Plugging Procedure Federal 23 #1 API No. 30-041-10527 M-23-07S-33E 660 FSL 660 FWL

Federal 23 1 30-041-10527 Ridgeway Arizona Oil Corp May 16, 2016 Conditions of Approval

Permanent Abandonment of Federal Wells Conditions of Approval

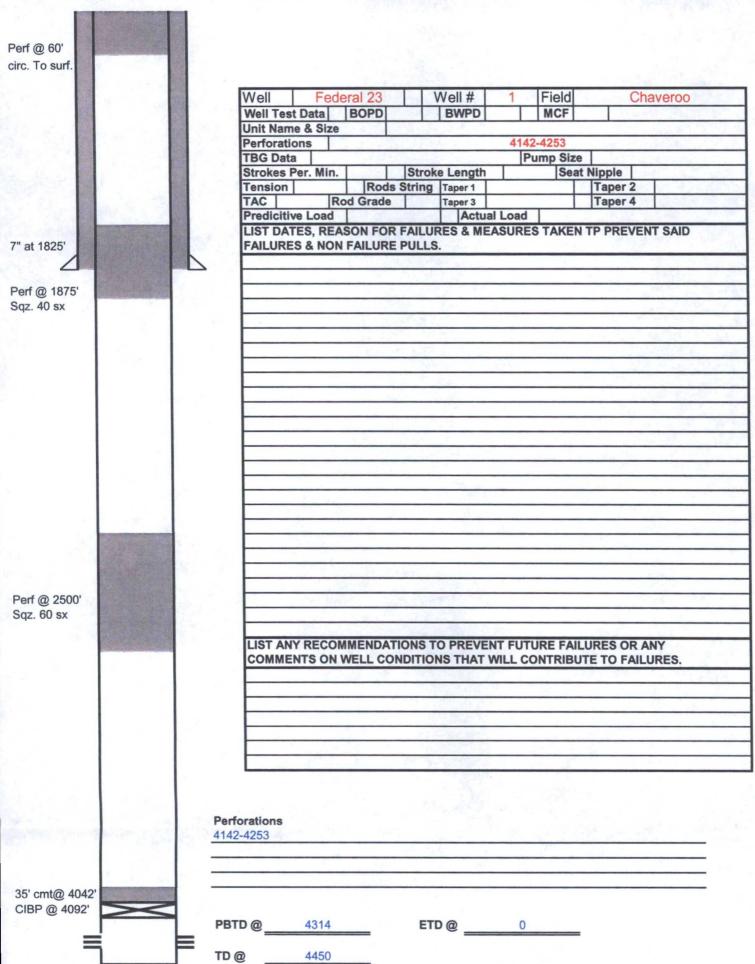
Haditional plugnelded 2300'-2175' to seal yaks. See (DA).

- 1. Operator shall place CIBP at 4,092' (50'-100' above top most perf) and place 35' of Class C cement on top as proposed. WOC and TAG.
- 2. Operator shall perf and squeeze at 2,500'as proposed tagging plug at 2,300'.
- 3. Operator shall place a balanced Class C cement plug from 2,300'-2,175' to seal the top of the Yates formation. WOC and TAG.
- 4. Operator shall perf and squeeze at 1,875' as proposed tagging plug at 1,775' to seal the surface shoe.
- 5. Operator shall place a balanced Class C cement plug from 60'- surface as proposed
- 6. See Attached for general plugging stipulations.
